Access Compliance Report

Public Rights-of-Way

(Pedestrian Signals)

Intersection ID: N/A	Main Street:	Cross Street: N/A	Location: N/A
ADA ID: 0DBA392D78E7	Signal Type: One Push Button-APS	Overall Compliance: No	Severity Score: BTN 1: N/A BTN 2: N/A No BTN: N/A
Codes/Mitigation Info/Possible Solution		Field Measurements/Component Compliance

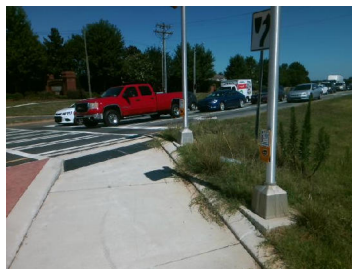
N/A	B 1 FWD Approach Width (in)	60.0	N/A	B 2 FWD Approach Width (in)	N/A
N/A	B 1 FWD Approach Obstruction?	Yes	N/A	B 2 FWD Approach Obstruction?	N/A
N/A	B 1 FWD Approach Obstruction Dist (in)	14.0	N/A	B 2 FWD Approach ObstructionDist (in)	N/A
N/A	B 1 PARA Approach?	Yes	N/A	B 2 PARA Approach?	N/A
N/A	B 1 PARA Approach Constrained?	No	N/A	B 2 PARA Approach Constrained?	N/A
No	B 1 PARA Approach Reach (in)	16.0	N/A	B 2 PARA Approach Reach (in)	N/A
N/A	B 1 PARA Approach Width (in)	60.0	N/A	B 2 PARA Approach Width (in)	N/A
N/A	B 1 PARA Approach Obstruction?	No	N/A	B 2 PARA Approach Obstruction?	N/A
N/A	B 1 PARA Approach Obstruction Dist (in)	14.0	N/A	B 2 PARA Approach ObstructionDist (in)	N/A
No	B 1 Clear Floor Space Slope (%)	7.6	N/A	B 2 Clear Floor Space Slope (%)	N/A
Yes	B 1 Clear Floor Space XSlope (%)	2.0	N/A	B 2 Clear Floor Space XSlope (%)	N/A
N/A	B 1 PAR Slope (%)	7.2	N/A	B 2 PAR Slope (%)	N/A
Yes	B 1 Height (in)	31.0	N/A	B 2 Height (in)	N/A

Possible Solutions: Remove & Replace
Replace APS Button With New APS Button.
Remove and Replace Clear Space.
